**Addendum 3**

Project No: 17017.00

Subject: Wyandotte Central Station Restoration

Date: 10-26-2017

**1ST FLOOR DEMO**

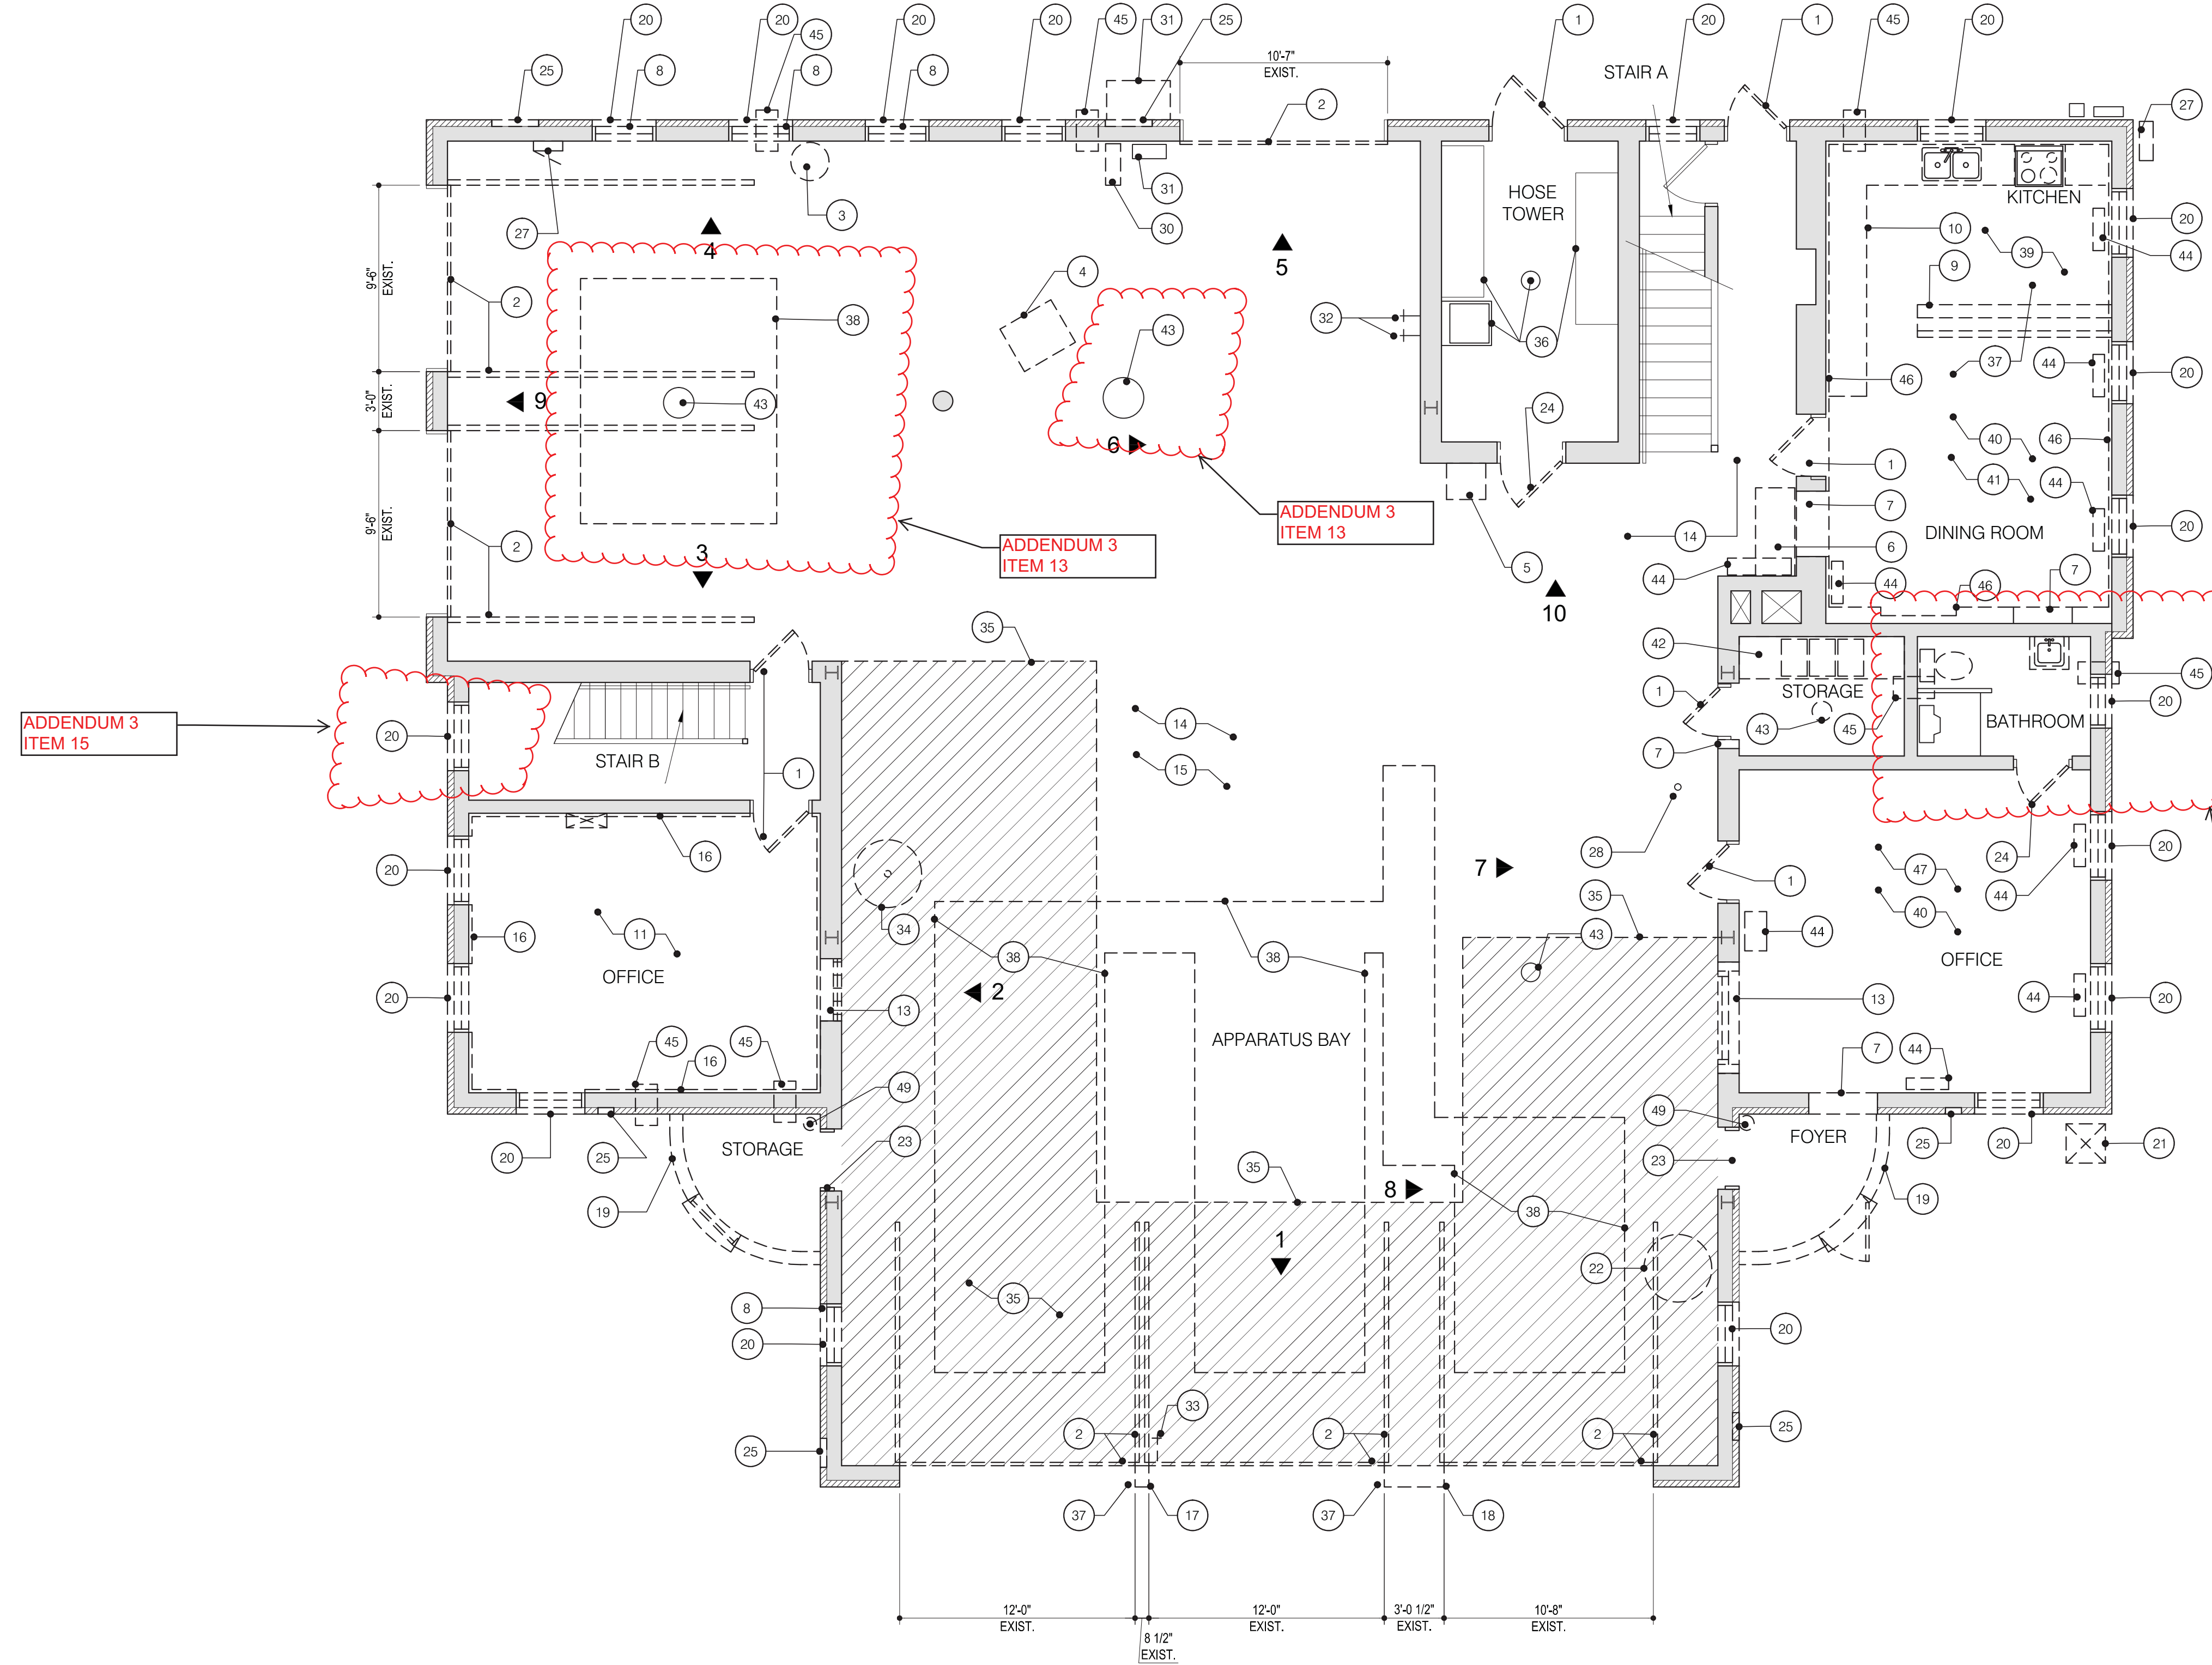
- e. **Bid Alternate 13:** New Floor Drains: (3) of the new trench floor drains called for within the Apparatus Bay 109 are to be eliminated from the project. (2) of the existing floor drains will now remain. (1) of those two existing drains is to be modified as to have the floor slab slope toward the drain. See attached drawing sheets D101 & A101 for revised plan.

- f. **Bid Alternate 14:** Leave first floor bathroom layout, walls, and finishes as-is. Replace the sink and toilet fixtures with new. Existing urinal to remain. Urinal drain to be repaired. Clean masonry walls. Paint walls and ceiling. Existing door frame to remain. Remove existing door leaf and hardware and replace with new door leaf & hardware. See attached drawing sheets D101 & A101 for revised plan.

- g. **Bid Alternate 15:** Eliminate new door 113A from project. Existing window to be replaced with new window in lieu of new door. Elimination of the new door includes the associated exterior wall demo work and new exterior concrete walk/slab. See attached drawing sheets D101 & A101 for revised plan.

- m. **Bid Alternate 21:** The existing vehicle exhaust system is to remain in place (not removed and relocated through the new building addition). Reference demo notes and drawings: note 31 sheet D101, note 18 sheet D300. Existing exterior mounted motor and vent piping to be cleaned, primed, and painted black to match new windows and gutters.
5. Questions and Answers: Bidders are advised to read all questions and answered listed below for additional project information.

1  
A002 Landscape Plan  
3/32" = 1'-0"

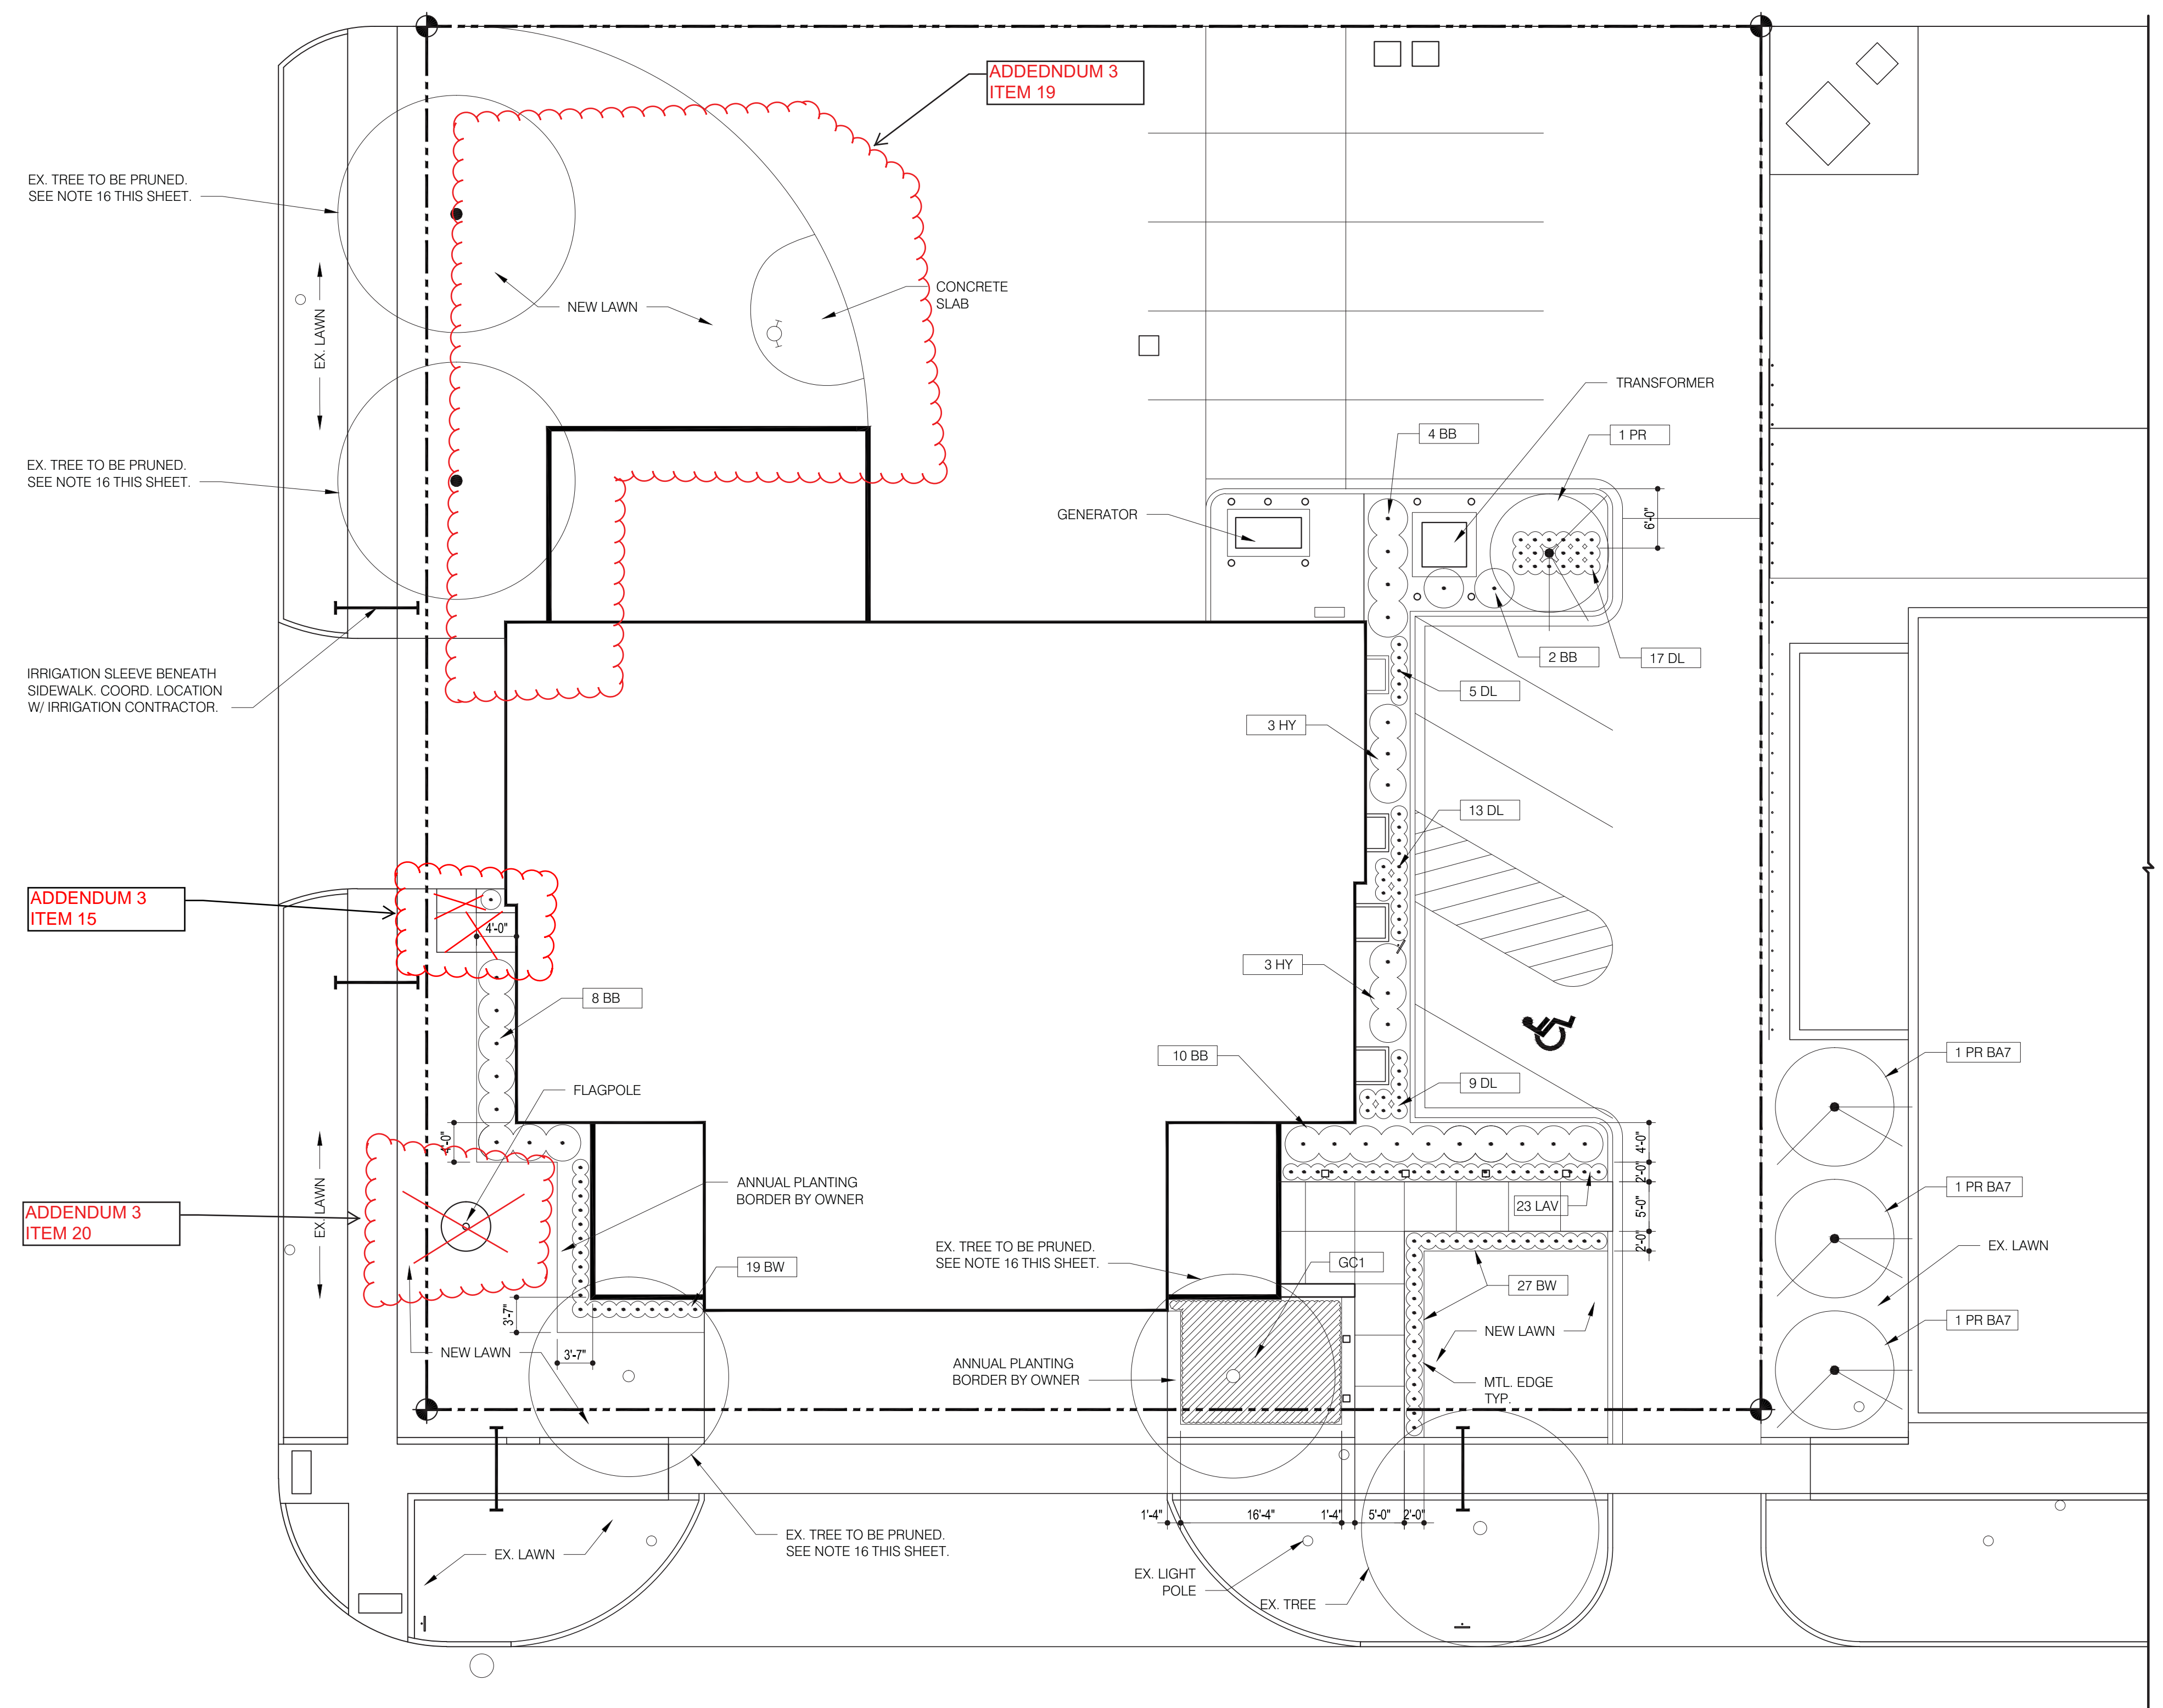
- j. **Bid Alternate 18:** Eliminate new drinking fountain within Weight Room #206. See attached drawing sheet A102 for revised plan.
  - k. **Bid Alternate 19:** Remove new landscaping located at rear (alley facing side) of building. See attached drawing sheet A002 for revised plan.
